VENDOR SERVICE BULLETIN
ATA 26-24
FIRE PROTECTION – FIRE EXTINGUISHER -
HIGH TEMPERATURE EXPOSURE - INSPECTION

PART MANUFACTURER	umlaut engineering GmbH
AFFECTED PART	Hand-held Fire Extinguisher HAFEX, model type: P3APP003010A P3APP003010B P3APP003010C

Figure 1: RFID Label.

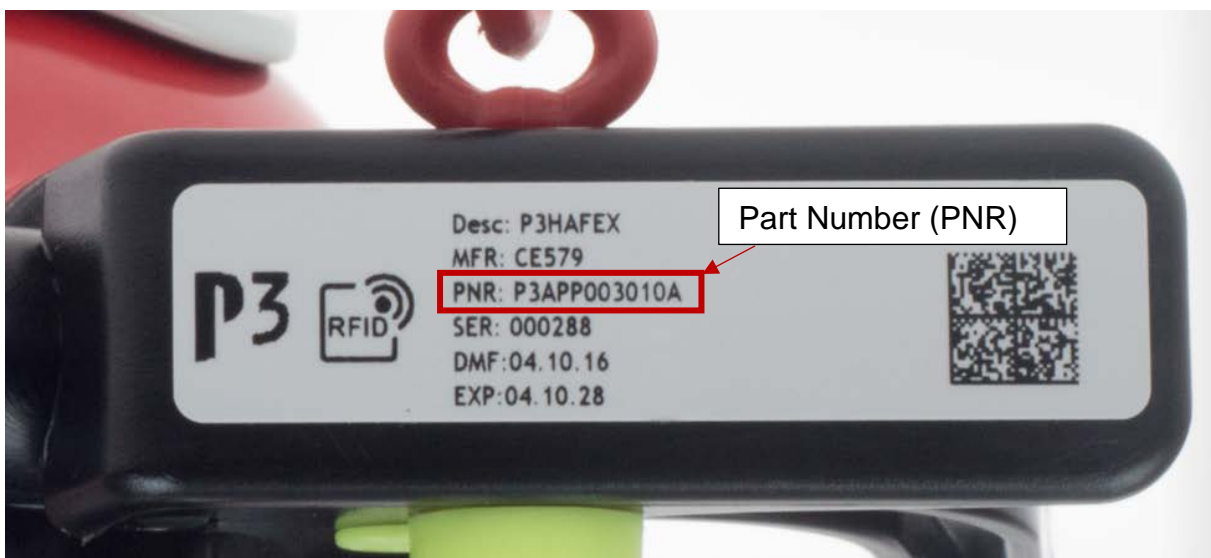
On the RFID label located on the lever of the fire extinguisher, check the part number (PNR). Only PNR P3APP003010A, P3APP003010B, P3APP003010C are subject to this service bulletin. (refer to Figure 1).

Figure 2: upright position

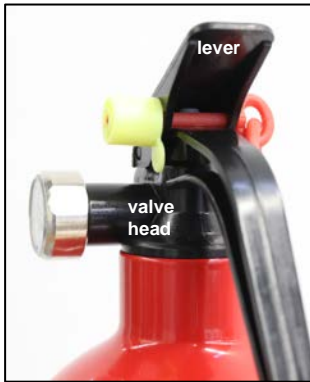
1. Remove the fire extinguisher from its bracket. **Refer to CMM 26-24-02 page 12001.**
2. Put extinguisher in upright position onto a flat and even surface with safety pin in place (Figure 2).
3. Push the lever up carefully with low force and using only one finger (Figure 3).
4. Release the lever.

Figure 4: gap

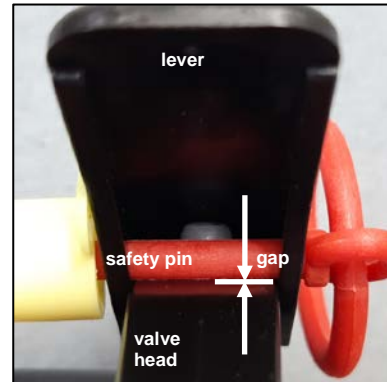
5. Check presence of potential gap between safety pin and valve head (without touching the lever): check visually if the safety pin touches the valve head (Figure 4).

- a. Case 1: safety pin touches valve head: the extinguisher can be considered as not affected. No further action needed.
 - b. Case 2: safety pin does not touch valve head: If there is a gap or in case of doubt, proceed with step 6.

- a. Case 3: If the lever stays in its position without moving up on its own (without a gap between safety pin and valve head, refer to Figure 4): the extinguisher can be considered as not affected. No further action needed.

- b. Case 4: If the lever moves back up into its previous position on its own (showing the potential gap again), the extinguisher might be affected in its function and should be considered INOP and should be replaced according to instructions provided by the design holder.
